REMINGTON MODEL 887 NOTICE

PRODUCT SAFETY WARNING AND RECALL NOTICE

REMINGTON MODEL 887™ SHOTGUN RECALL

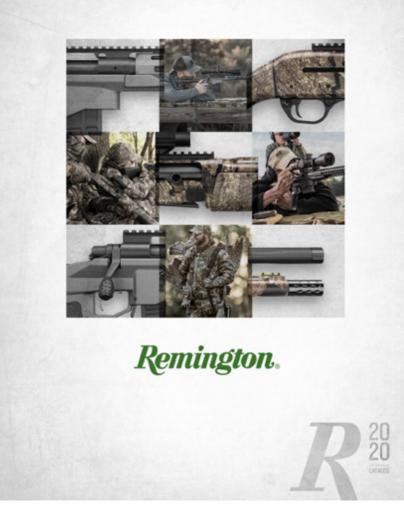
<u>VERIFICATION OF CORRECTIVE ACTION</u>: Upon repair of your shotgun, you will note a punch mark on the bolt (see photo below). This mark confirms your shotgun has been inspected and repaired by Remington under the recall program.

Remington has also corrected the manufacturing process to eliminate this potential firing pin problem in shotguns manufactured after November 24, 2014. Shotguns manufactured after November 24, 2014 will also have a punch mark on the bolt.
